**Village of Somers
7511 12th Street
Somers, WI 53171**

**Village Board Meeting
Agenda
Tuesday, May 27, 2025
5:30 p.m.**

AGENDA ITEM: #7 Action on Plan Commission Recommendations (Willow Creek):

TO: Village of Somers Plan Commission
FROM: Luke Godshall, Senior Land Use Planner
APPLN DATE: 03-28-25
RPT DATE: 04-28-25
MTG DATE: 05-12-25
RE: Willow Creek Rezoning & Preliminary Plat

SHEET
3
 PEG JOB No. 1617.00
 REG. NO. AEK
 START DATE 3/28/25
 SCALE 1" = 80'

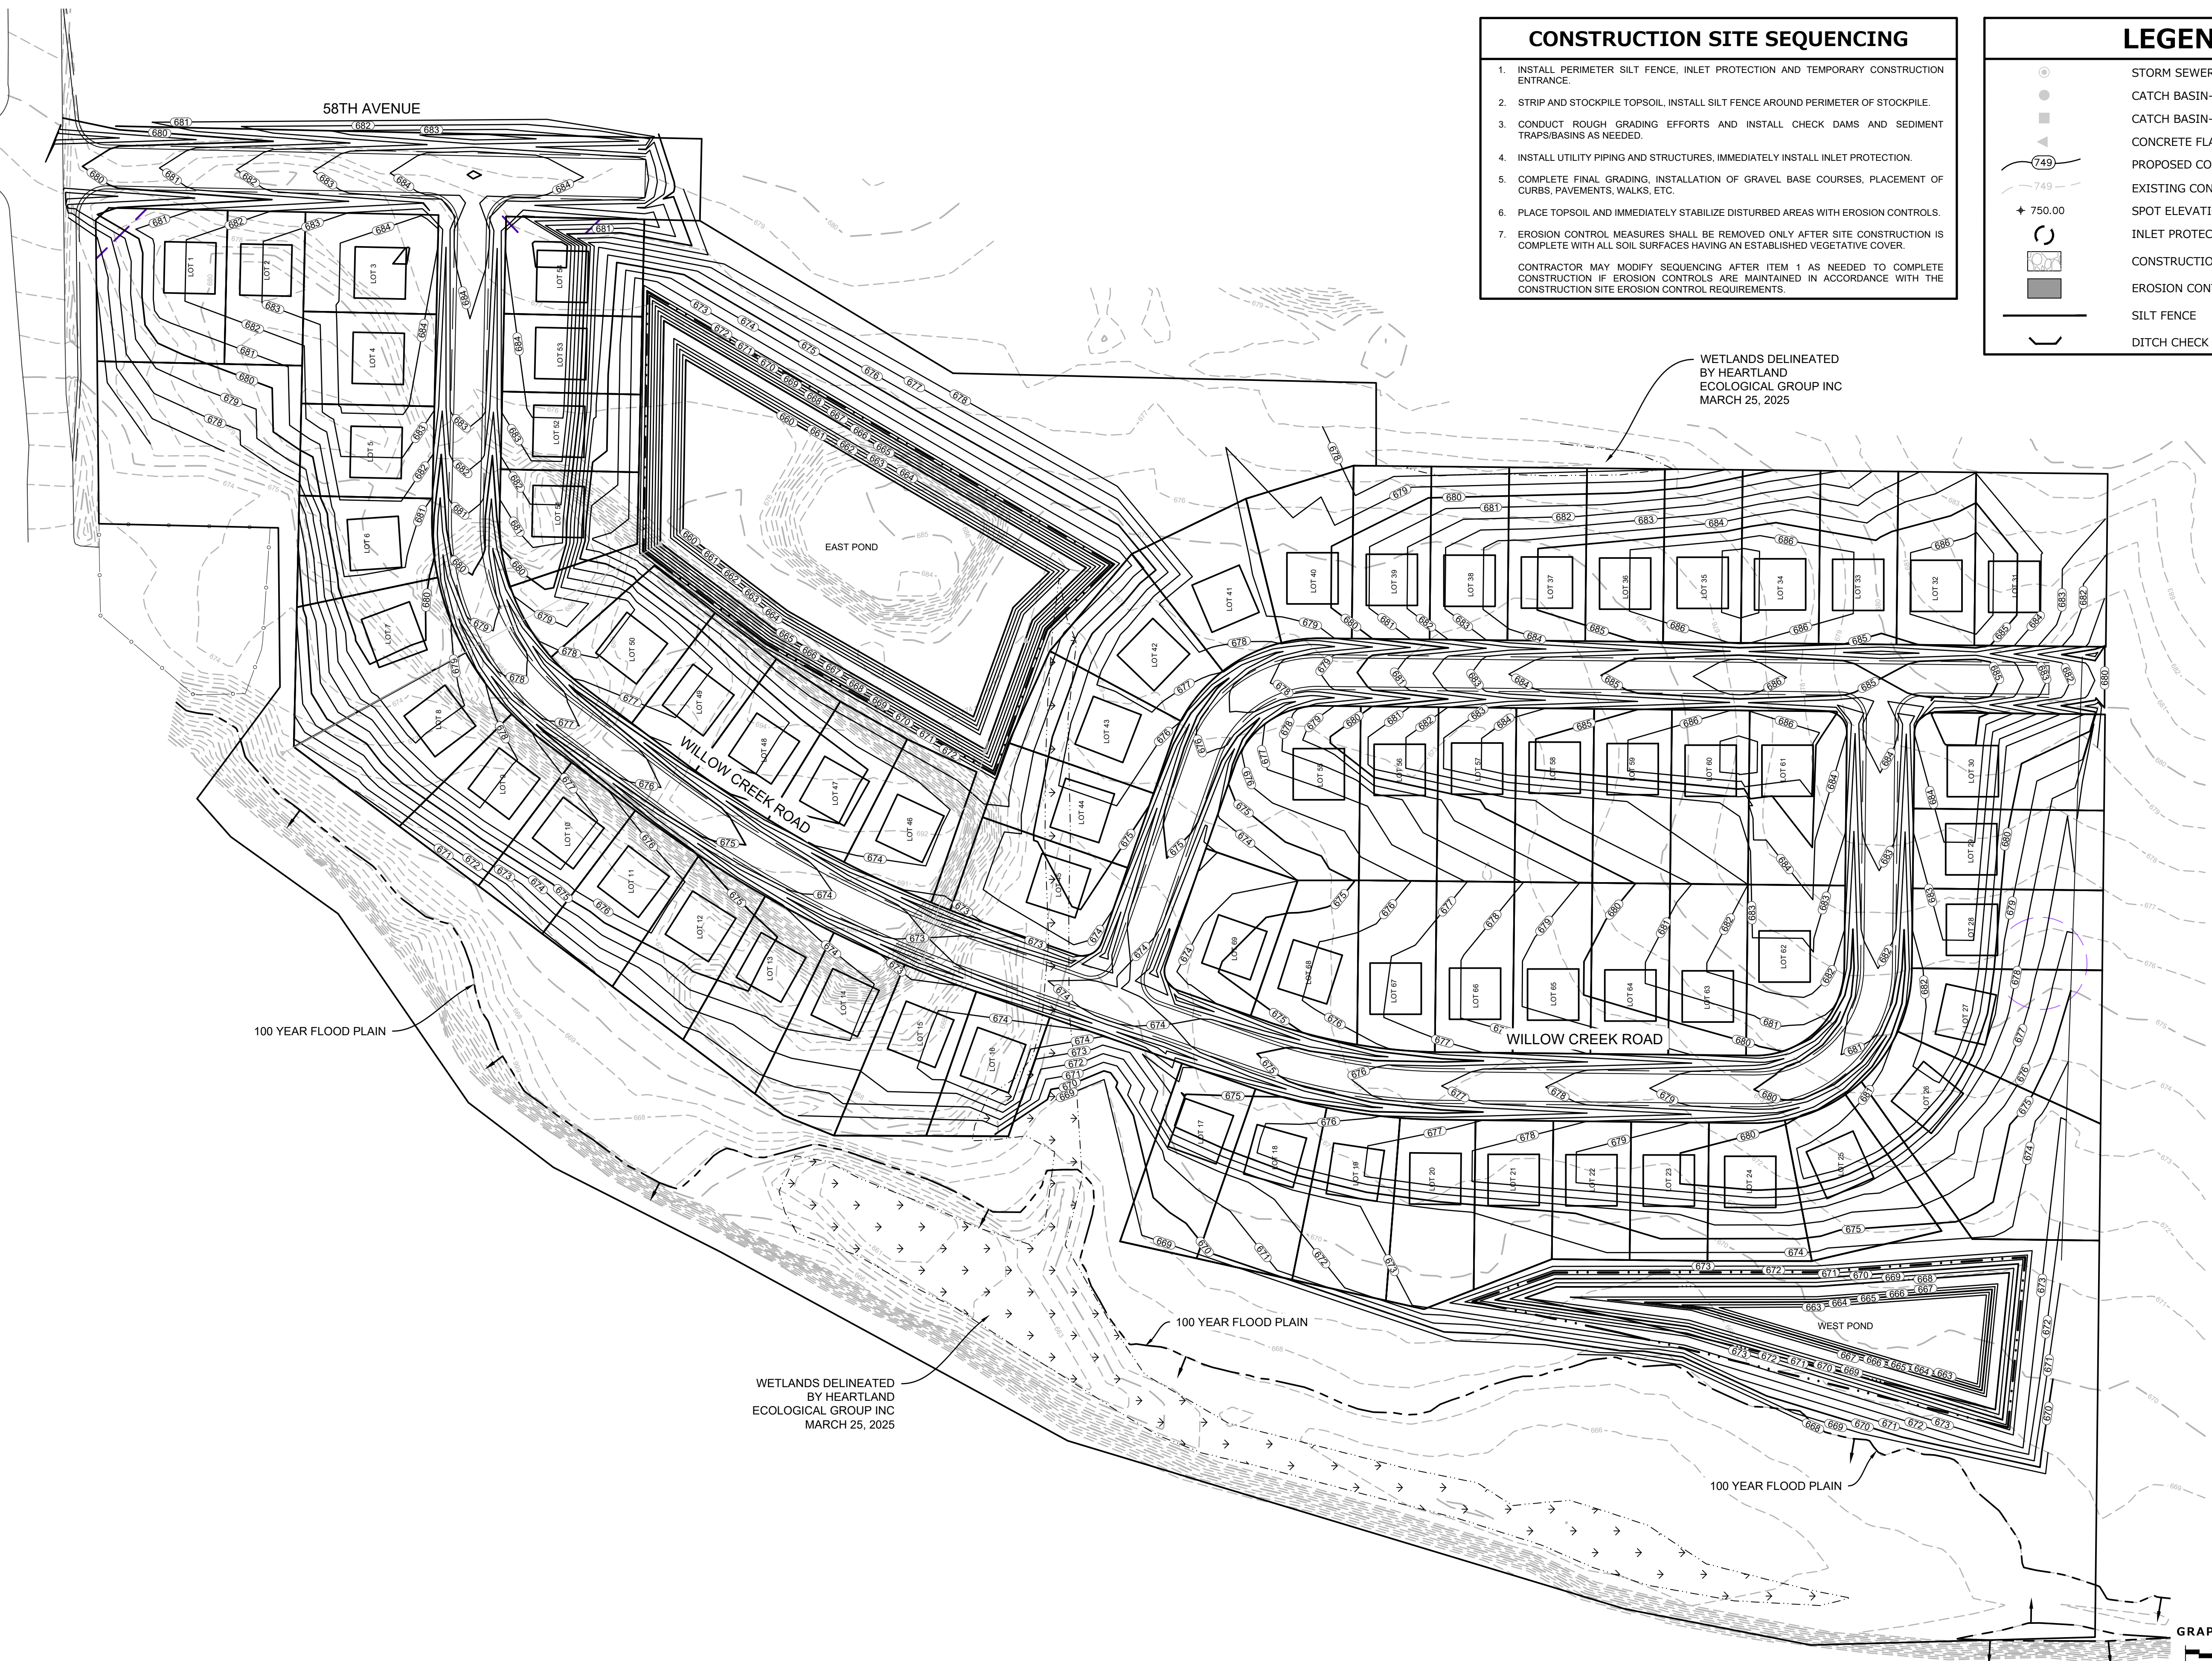
1. Sheet 3: Provide an emergency pond overland flow route.
2. Sheet 4:
 - a. Provide a 24-inch water main on the entrance road (58th Ave.).
 - b. The east pond discharge conflicts with an existing sanitary manhole.
 - c. The sanitary sewer tie-in manhole has an existing outside drop. As-builts have been provided.
 - d. Provide permit for wetland disturbance.
 - e. Provide an 8-inch sanitary sewer stub and easement to serve property to the east.
 - f. Coordinate future water main and sanitary sewer extensions to the south with the gas pipeline utility.
